APPEAL REPORT

East Los Angeles Area Planning Commission

Case No.: DIR-2020-427-SPP-1A
CEQA No.: ENV-2020-428-CE
Incidental Cases: None
Related Cases: DIR-2020-427-SPP
Council No.: 1-Cedillo
Plan Area: Northeast Los Angeles
Specific Plan: Mount Washington-Glassell Park Specific Plan
Certified NC: Arroyo Seco
GPLU: Low Residential
Zone: R1-1

PROJECT LOCATION: 464 North Crane Boulevard

SITE PLAN
SCALE: 3/16"=1'-0"

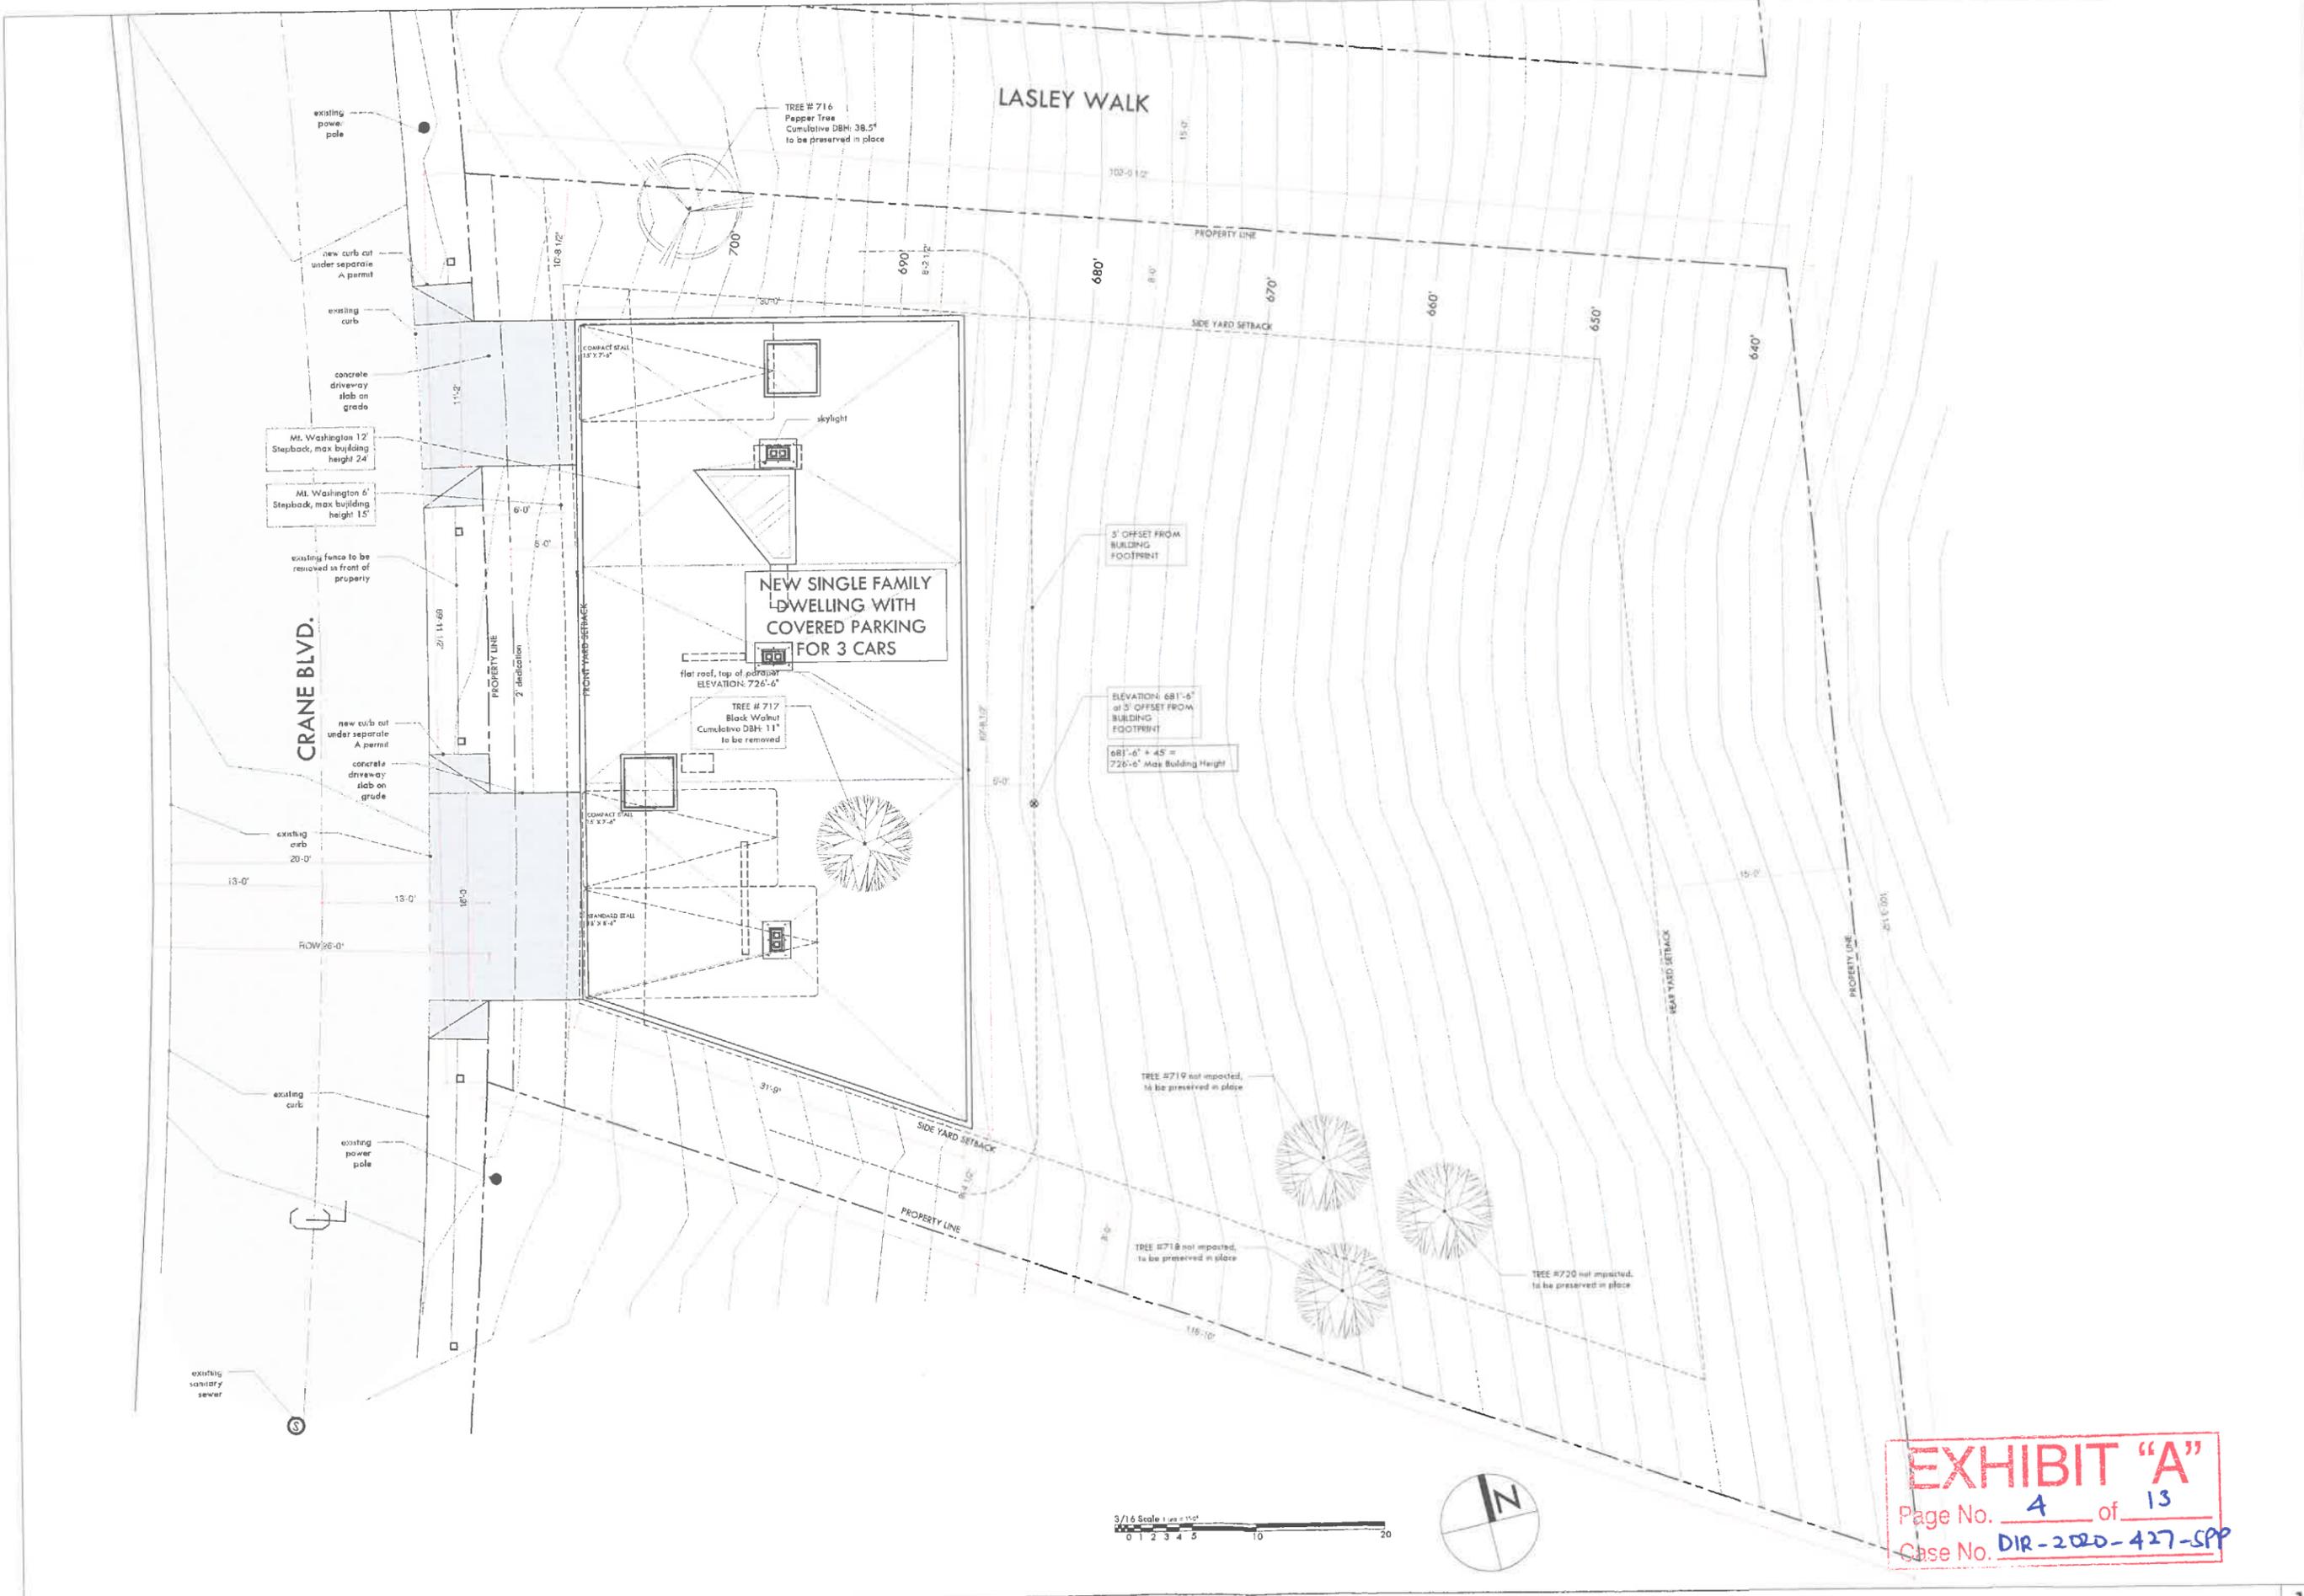
A preliminary review of the project plans appears to show that certain areas of the structure have been excluded from the floor area calculation in violation of both the Specific Plan or the BHO. Thus, no matter which law is applied, the structure appears to be inconsistent with proper floor area calculations.

The Specific Plan has a defined formula for properties that are more than 5,000 square feet but less than 10,000 square feet in size, and the Plan does not require the preparation of a slope analysis map to calculate the floor area. The Specific Plan determines a maximum Floor Area Ratio (FAR) for the subject lot by using the following equation: $0.50 - \{[(\text{Lot Area} - 5,000) \times 0.10] \div 5,000\}$. For this project, the lot size is 8,914.1 square feet, and therefore the allowable maximum FAR based on the formula is 0.42:1 or 3,743.92 square feet. As the project proposes an FAR of 0.41:1 or floor area of 3,633 square feet, the project would be in conformance with Section 6.A of the Specific Plan. This FAR calculation is shown on Page 1 of the Project Plans (Exhibit C, Sheet A-000-1). The proposed floor area of 3,633 square feet includes a 533-square foot Garage, 640 square feet on the First Level, 873 square feet on the Second Level, 1,298 square feet on the Third Level, and a 469-square foot Covered Deck.
